Subject: Response to Items Requiring Resolution Evaluation
of Emergency Plan Supplement No. 3, NUREG-0798,
January, 1983

DETROIT EDISON'S RESPONSES
TO THE
ITEMS REQUIRING RESOLUTION
EVALUATION OF THE EMERGENCY PLAN
SAFETY EVALUATION REPORT
RELATED TO THE OPERATION OF
ENRICO FERMI ATOMIC POWER PLANT, UNIT 2
NUREG-0798 - SUPPLEMENT NO. 3
JANUARY 1983

NUREG-0798 - SUPPLEMENT NO. 3
EVALUATION OF THE EMERGENCY PLAN
RESPONSES TO ITEMS REQUIRING RESOLUTION

ESTIMATE OF ACTIVITY IN CONTAINMENT
CONTAINMENT HIGH RANGE RADIATION MONITOR
FERMI - 2

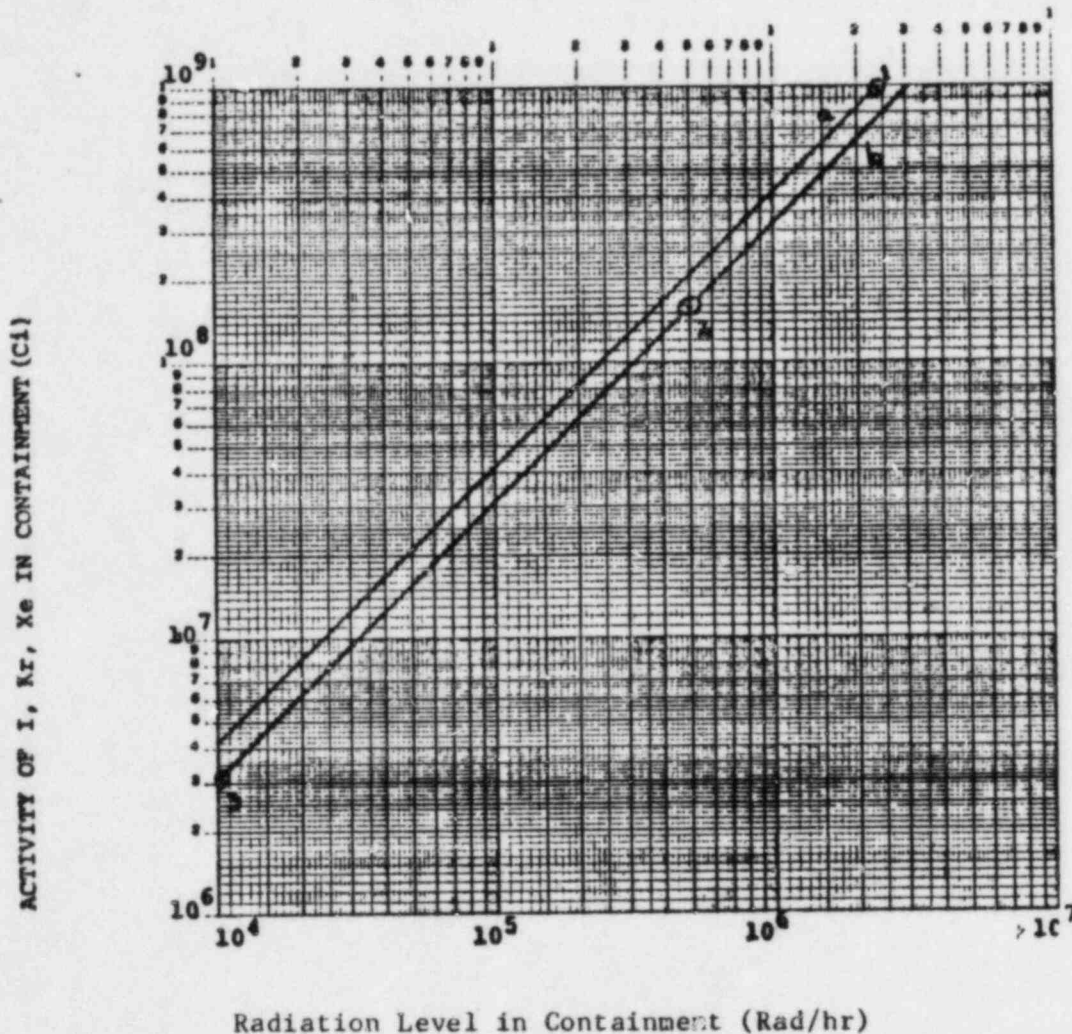
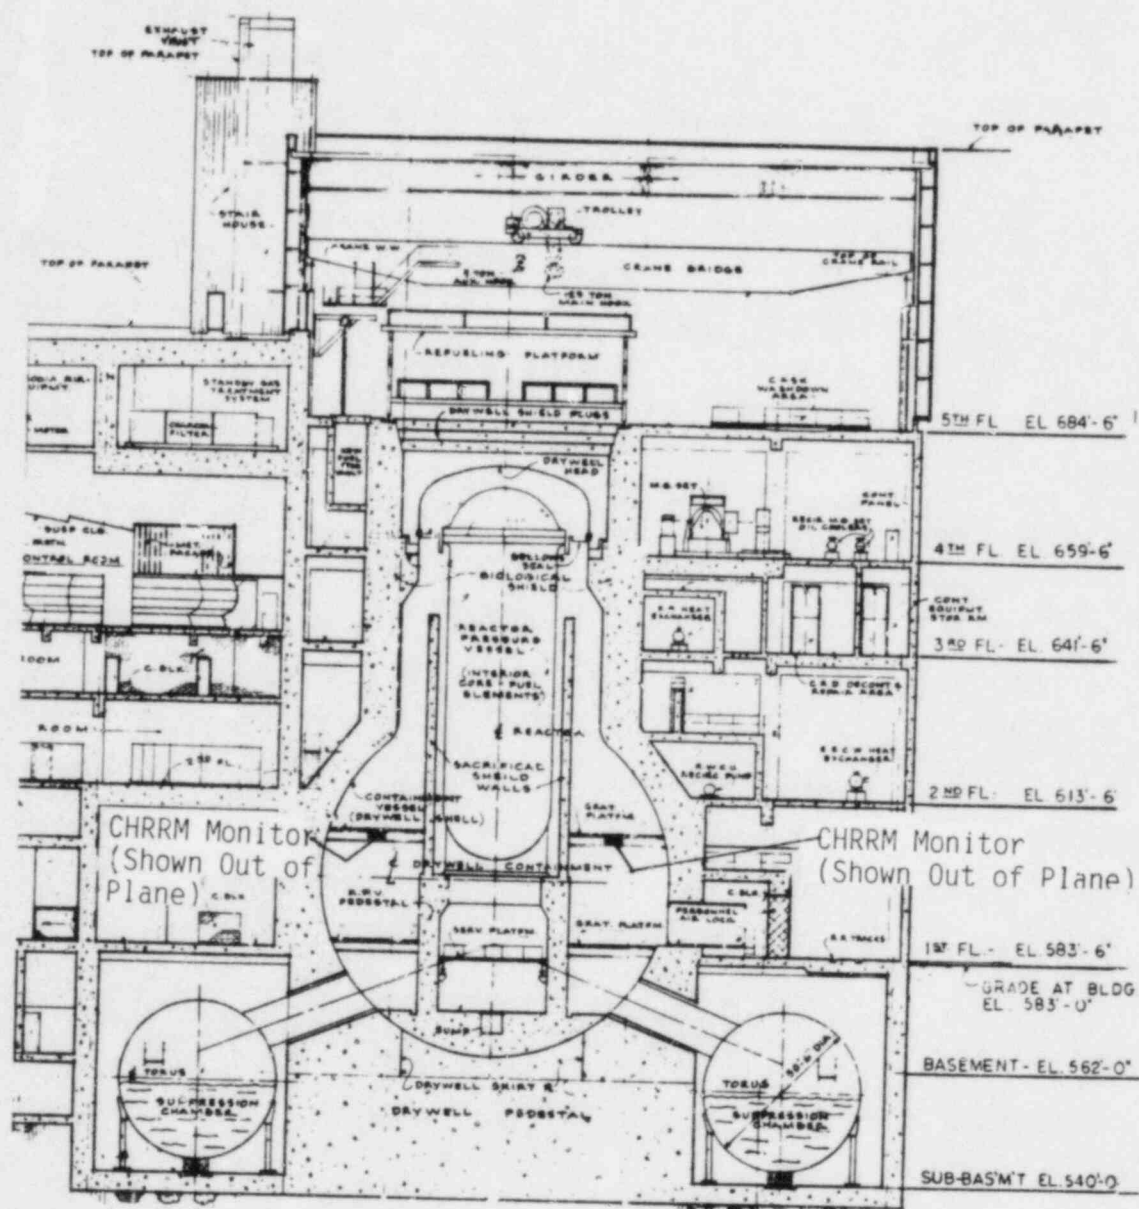
- (2) Correlate the containment (drywell) monitor and other key instrument readings, if applicable, to a range of degraded core conditions. Selected values from this analysis along with other indicators of core and containment conditions should be included in the EALs and used to initiate protective actions in accordance with the guidance in NUREG-0654, Appendix 1 for general emergencies.

A correlation may be made with the CHRRM reading and the amount of radioactivity released to the drywell that will become airborne. Thus, a correlation can be made for accidents ranging from a release of all coolant and core damage to a classic Regulatory Guide 1.3 Loss-of-Coolant-Accident (LOCA) which assumes the release of 100% of all noble gases and 25% of the iodines to the drywell volume. This set of curves was provided as Enclosure 2 of the Fermi 2 RERP Plan Implementing Procedure EP-540 (Enclosed).

Values given in the curves of Enclosure 2 of EP-540 were obtained as follows. The dose rate at the CHRRM location due to 100% of the core inventory of noble gases uniformly distributed in the drywell volume was calculated to be 1.40×10^6 R/hr; the dose rate due to 2% of the iodines similarly distributed was found to be 7.55×10^4 R/hr. From these values, the dose rate due to any postulated fraction or combination of releases may be calculated. As an example, the enclosed table has been constructed. This information will be included in a procedure.

Curve "a" represents estimated activity levels in the containment following releases in which the ratio of "% noble gases released from the core" to "% iodines released from the core" is equal to 4. Curve "b" represents estimated activity levels in the containment following releases in which the above mentioned ratio is equal to 1. Specifically, the following points are plotted:

1. 100% noble gases, 25% iodines released
2. 10% noble gases, 10% iodines released
3. 0.2% noble gases, 0.2% iodines released

Coolant activity is equal to 19 curies. If airborne in the containment, the radiation level would be 0.01 Rad/hr, too low to plot on this graph.
